CE NPSD-1199
Project Number 694

**Subject: Westinghouse Owners Group Response to Request for
Additional Information on CE NPSD-1199, "Model for Failure
of RCP Seals Given Loss of Seal Cooling" (TAC No. MB5803)**

CE NPSD-1199-NP, "RCP Seal Failure Model"
Response to Request for Additional Information dated July 24, 2003

Figure 2.1-1: Idealized RCP Seal Stage Force Balance

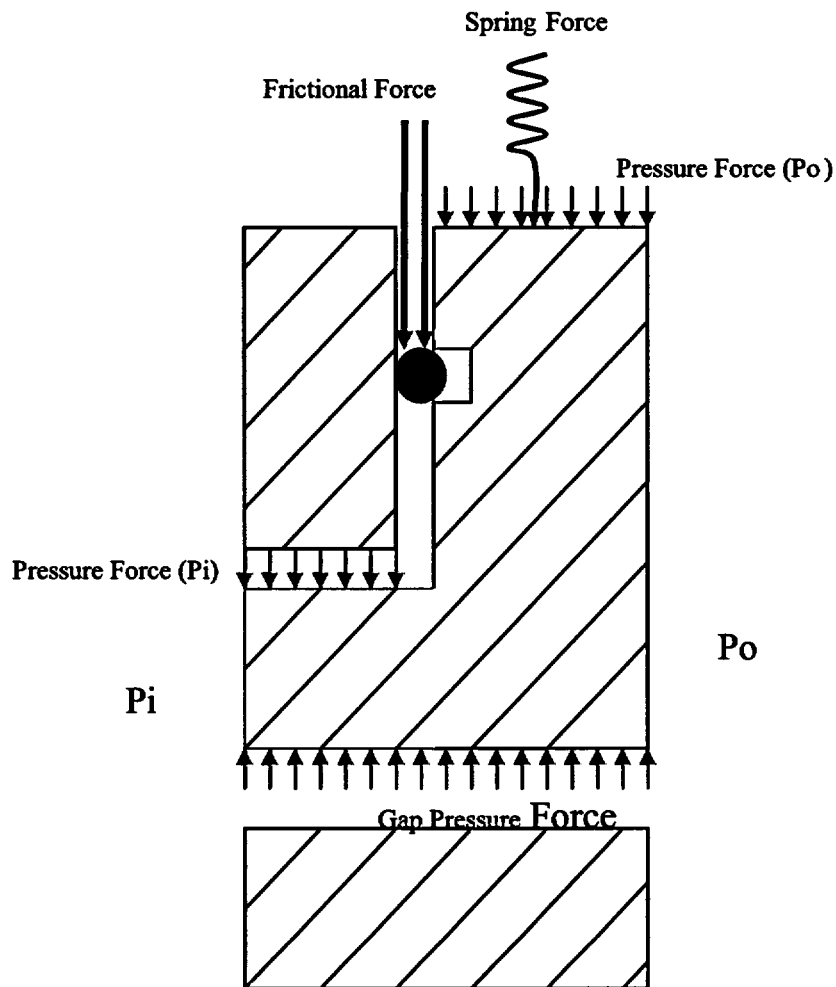
In the response to staffs request for additional information RAI 16 (page 36 of the responses to the RAIs), it is mentioned that when the controlled bleed-off (CBO) is not isolated, the inlet fluid to the vapor seal is not subcooled, but the pressures are not high enough to challenge the vapor seal. However, according to Table 5.3-2a of CE NPSD-1199, the outlet pressure to the vapor seal is less than one-half the inlet pressure to the vapor seal. Thus, neither of the conditions which would ensure the stability of the vapor seal are present and the seal may pop open. Data was discussed in the response to RAI 2 (page 4 of the responses to the RAIs) which indicated that in tests the vapor seal did not pop open. However, there is no subcooling in the case where the CBO is not isolated (fluid is at saturation conditions), so the test results may not be applicable. How then is the probability of failure for the vapor seal, (used, for example, in Table 9.2-15A of the revised Section 9 given in the responses to the RAI) justified?

Evaluation of seal events on CE PWRs indicates that the middle seal stages are the more likely to experience "pop-open." While small leakages may be observed through the vapor seal, no catastrophic failure has been noted. While detailed thermal-hydraulic behaviors could not be confirmed for most of these events, it is expected that vapor seal operation was in or near saturation for conditions where CBO was not isolated. Experimental data with CBO operation is limited. However, tests conducted by Byron-Jackson for the loss of component cooling water (Reference 2.1-1) and for station blackout (Reference 2.1-2) seal performance also indicated periods of two-phase and near two phase conditions in a vapor seal while seal leakage remained small (< 0.5 gpm). Specifically in one loss of coolant test the RCP seal cartridge was operated for a period of 30 minutes without seal cooling. The seal cartridge remained operational and the controlled bleedoff (CBO) was not isolated during the test interval. A review of the seal temperature and pressure data indicates a period of ~ 10 minutes where the vapor cavity was nearly saturated (within $\sim 10^\circ\text{F}$ of saturation) or saturated. Vapor seal leakage measurements conducted at the time indicated seal leakages < 0.26 gpm. No "pop-open" behavior was observed, even though the backpressure to vapor seal cavity pressure ratio was much less than one half. The total upward force (F_{up}) exerted by the fluid in the seal gap was compared to the total downward (restorative) force (F_{wt}) acting on the RCP seal upper face for the N-9000 seal design. This comparison demonstrated that at these lower absolute pressure conditions the upward force generated in the seal by the seal leakage is insufficient to overcome the downward seal force and hence the seal would not "pop-open."

The conceptual seal design is presented in Figure 2.1-1. The downward force is a result of the combined upstream and downstream pressure loads on associated areas, friction and spring load. The upward (or opening) force is based on the fluid pressure in the seal gap. The capability of the seal to remain closed under a pressure differential is based on a balance between the total downward force (F_{wt}) and upward gap pressure force (F_{up}) assuming that the pressure of a two-phase mixture results in a critical flow condition in the seal gap.

Results of the evaluation are summarized in Figure 2.1-2. At pressures up to []^{a,c} psia (backpressure rates of []^{a,c}) the net seal downward load is sufficient to maintain the vapor seal stage integral.

Based on this force comparison, it was concluded that at low upstream RCP seal pressures (at least up to []^{a,c} psia), the functional capability of the RCP seal vapor stage is assured despite the fact that the seal back pressure is less than 50% of the upstream pressure (a rule of thumb to estimate seal stability).

Fig. 2.3-1: Value of F_{No}^2 as a Function of Pressure and Mass Quality (Martinelli-Nelson)

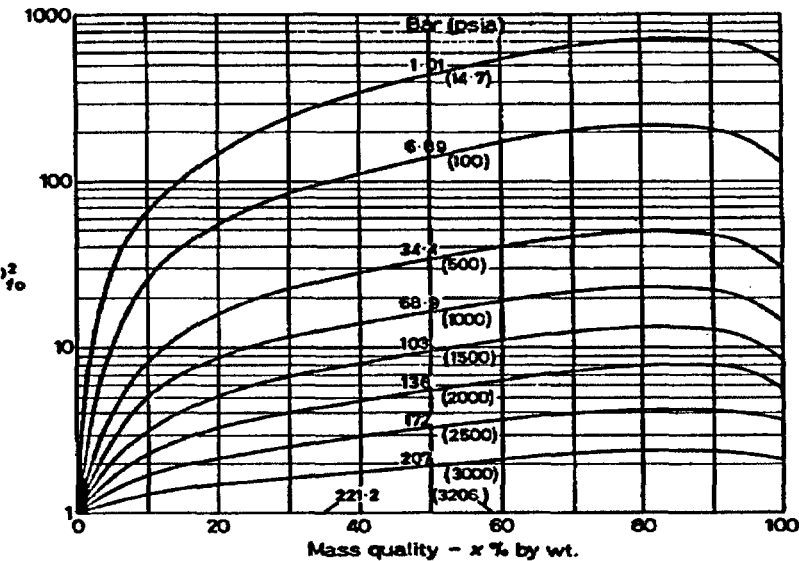
Table 5.3-2a of CE NPSD-1199-P, for post-accident conditions following a station blackout (SBO) event, gives the pressures and temperatures at the inlets to the various seal stages. Consider the case where the CBO is not isolated. Here, the pressure is assumed to drop uniformly across the first three seal stages. The pressures given in Table 5.3-2a of CE NPSD-1199-P are based on the assumption of a uniform pressure drop across the first 3 stages. This is a reasonable assumption for normal operation. However, as several stages will experience two phase conditions, the pressure drops in the pressure breakdown devices will be influenced by flashing. This is particularly significant for those seal stages that appear to indicate the presence of a superheated condition. Under these conditions the pressure drop across the various seal stages will not be uniform. Likely, the flow resistance will be greater where saturated and supersaturated conditions occur. The flow model has to take into account the flashing of the water in the pressure breakdown devices and controlled bleed-off line. Once the pressures are recalculated, the probability of seal failure may change, and the applicability of loss of seal cooling events may be affected. Please analyze.

The pressure distributions presented in Table 5.3-2a as with the other related tables indicated "representative" seal stage pressures and subcooling. Regardless of the displayed subcooling, setting the "pop-open" failure probability for the internal seal stages (seal stages 2 and 3) was assumed that both internal stages were saturated and subject to "pop open."

To demonstrate the impact of two-phase flow through the seal pressure breakdown devices (PBDs) and controlled bleedoff (CBO) line, a limited scope analysis was performed. The intent of the calculation was to predict the impact of the emergence of two-phase conditions on the RCP seal stage pressure distribution and the pressure drop in the CBO line. The calculation assumes the CBO line is not isolated and the enthalpy losses of the liquid in the seal are negligible. The CE NSSS RCP seal design is such that the seal stage pressure drops are controlled by the PBD flow. The pressure drop through the PBD are calculated using the Martinelli-Nelson two-phase flow multiplier (Reference 2.3-1, Two-phase multiplier charts are reproduced below, see Figure 2.3-1). This correlation provides the two-phase multiplier ($F_{2\phi}$) as a function of pressure and mixture quality.

Using this methodology, revised pressure drops were calculated for the various seal stages. Since the RCS and downstream CBO discharge pressure at the volume control tank are relatively fixed, increasing the PBD resistance across saturated and nearly saturated stages will both (1) reduce the CBO flow and (2) skew the pressure distribution such that the larger pressure losses will be taken across the third stage (last PBD). A comparison of the linear single-phase distribution and the alternative distribution accounting for two-phase flow phenomena is presented in Table 2.3-1. Note that the effect of the increased resistance is to reduce the pressure drop across seal stages 1 and 2, further stabilizing both.

In summary, consideration of two-phase conditions in the RCP seal indicates that while the seal pressure distribution is not linear, the two-phase behavior serves to stabilize the upstream seal stages by reducing the pressure drop of the upstream seals. Furthermore, as the risk model for both intermediate seals considered these seal stages to be subject to two-phase induced “pop-open”, the details of the pressure variation does not impact the risk model.
